UNITED STATES PATENT AND TRADEMARK OFFICE

APPLICATION NO.	FILING DATE	FIRST NAMED INVENTOR	ATTORNEY DOCKET NO.	CONFIRMATION NO.
10/814,597	04/01/2004	Jean-Pierre Rene Leon	403005/WEINSTEIN	5887
23548	7590	10/04/2005	EXAMINER	
LEYDIG VOIT & MAYER, LTD 700 THIRTEENTH ST. NW SUITE 300 WASHINGTON, DC 20005-3960			SHARP, JEFFREY ANDREW	
			ART UNIT	PAPER NUMBER
			3677

Office Action Summary

DETAILED ACTION

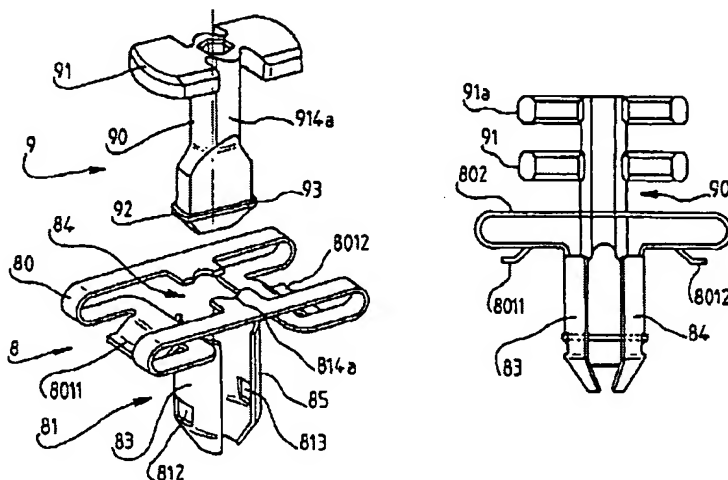
Leon et al. teach a female piece having a clasp, hollow elastically deflectable head, hollow foot portion having two tabs, and a male piece having a head (having a second head element (91), shaft, and cam portion. Broadly speaking, Leon et al. teach substantially all of the

claimed limitations, except for a **notch on the head** of the male piece that receives a **component** projecting from the head of the female piece -- said component comprising a resilient and axially-deflectable **finger** at its free end.

Higdon et al. teach a device for use in joining at least two panels together (Col 1 lines 7-9), comprising an anti-rotation apparatus. The anti-rotation apparatus has both *locked* and *unlocked* positions; both positions being facilitated by resilient, axially deflectable tab-like **components (70)** that extend from a female piece (30), and which have bent-like **finger portions** at their free ends. The fingers (70) are deflectable in an axial direction with respect to the shaft (54,60) axis of the male piece (50), and engage a **notch (68)** in the head (52) of the male piece (50), so as to prevent accidental rotation of the male piece (50) within the female piece (30). Accidental rotation of the male piece (50) is undesirable (as stated by Applicant in vibration environments), because it compromises the "separation of the tabs" and therefore threatens the "holding together a stack of panels". In order to achieve an *unlocked* position (i.e., position which allows rotation of the male piece (50) within the female piece (50)), the fingers (70) are axially deflected in between the two head portions (52, 56) and out of the notch (68) of the head (52). This is facilitated by cutouts (66), as Higdon et al. specifically disclose that clearance flats (i.e., "cutouts") are necessary for the first head portion (52) to clear the fingers (70) upon axial insertion of the male piece (50) into the female piece (30). See Higdon et al. Col 3 lines 26-38.

Leon et al WO-00/49299

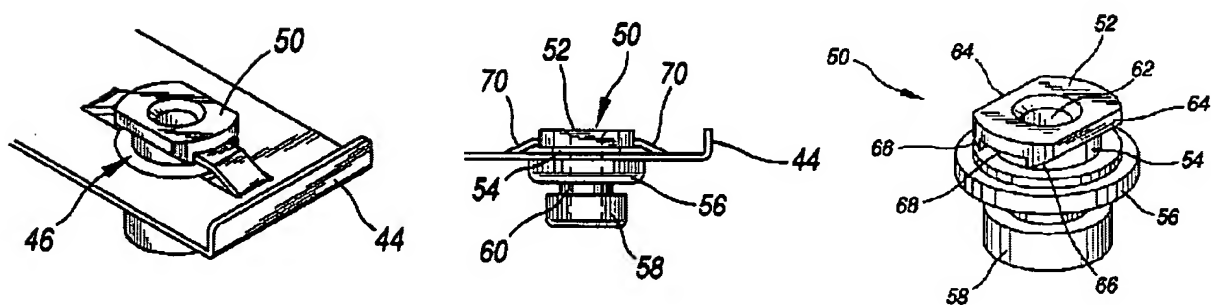
When construed broadly, the examiner maintains that the Leon et al. '299 reference suggests each and every limitation of claims 1-7, including the recited functional language and an immobilization element (91) on a male piece (90) comprising diametrically opposed portions/lateral protuberances which pass through a hollow (84) of the head (802) of the female piece (81).

Higdon et al. '065 suggests and makes obvious to one having an ordinary skill in the art, an improvement comprising providing at least one component/tab (70) which projects from a female piece (30) for fastening multiple panels (see title), said at least one component/tab (70) being engageable with at least one notch (68) in the periphery of the head (52) of a male piece (50).

This amendment is consistent with paragraph [0022] of the present specification and the drawings. Furthermore, Higdon et al. '065 would make obvious "cutouts" (64) and "notches" (68) on the head (52) of a male piece (50). Lastly, the peripheral areas of element (91) in Leon et al. '299 could be broadly construed as "cutouts", and it should be made clear that these cutout portions reside on the protuberances.

Delete "*being connected to the head of the male piece*" on line 6, and replace with:
extending radially from said shaft at a predetermined distance from the head of the male piece.

Replace "and" on line 8 with: said protuberances having.
